## 6. MODIFICATIONS TO THE CONCEPT PLAN (75W OF EP&A ACT)

As part of the Environmental Assessment (EA) submitted by the Proponent, a list of modifications to the Sandon Point Concept Plan (MP07\_0094) is requested in order to correct errors or inconsistencies within the Concept Plan approval and also allow for a revised location for the proposed townhouse lots (see pages 11-17 of the EA in **Appendix B**). The Department has also considered some minor amendments to the Concept Plan approval to correct further errors or inconsistencies. They are considered as follows:

**Figure 15.** *Proposed location of townhouse lots – note that the Concept Plan subdivision layout is 'proposed' not 'approved' as the development footprint was reduced as a modification of the approval*

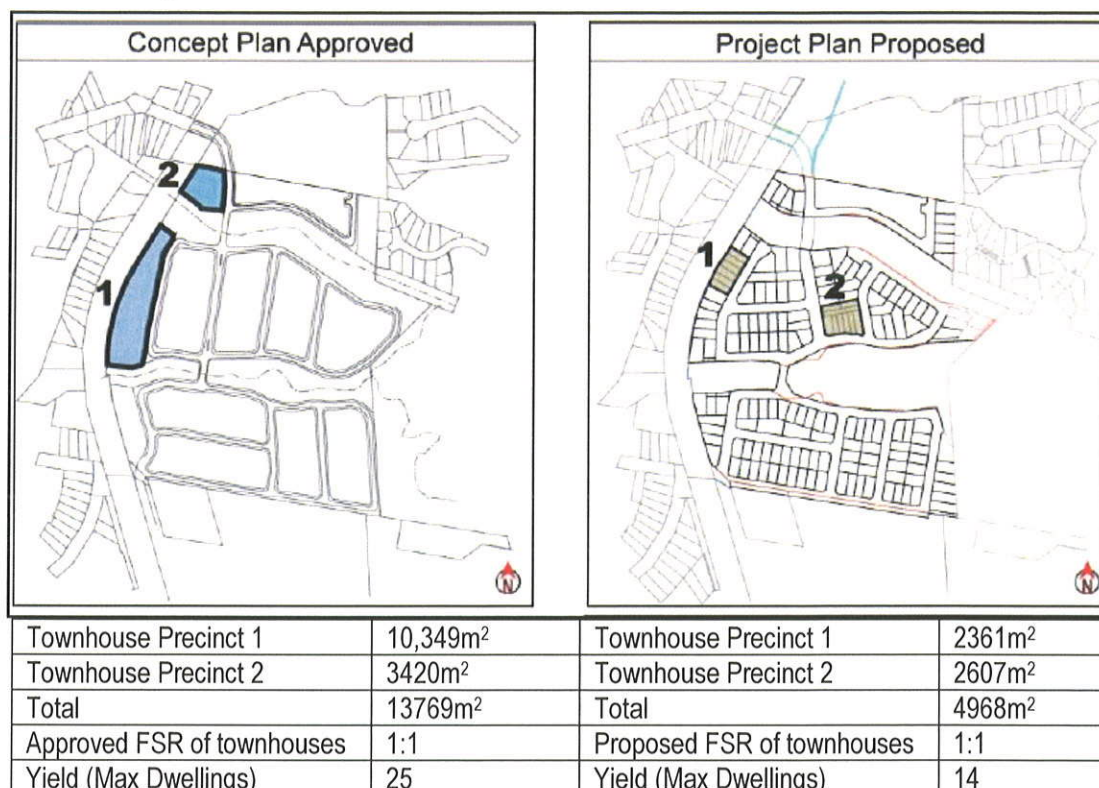
The townhouse lots are proposed to be reduced in number and their location revised from that outlined in the Concept Plan as illustrated in **Figure 17** below.

The proposed 'Precinct 2' of 8 townhouses is in an area outside of the indicative areas for townhouse super lots as outlined in the Concept Plan application and an amendment to the Concept Plan approval is therefore required. The Proponent states that the revised location of these townhouse sites is a response to the reduced development footprint required by Modification A1 of the Concept Plan Approval and is still consistent with the intent of the approval in terms of providing a mix of housing types.

In order to ensure that future approvals for housing development within the new townhouse precincts can be obtained with an FSR of 1:1, a modification to the Concept Plan approval is considered appropriate (refer below). The Department is satisfied the proposed townhouse lots are in an appropriate location and are consistent with the intent of the Concept Plan to provide a mix of housing types. The reduction in the total number of townhouse lots will also result in less impact (particularly traffic) than the approved Concept Plan.
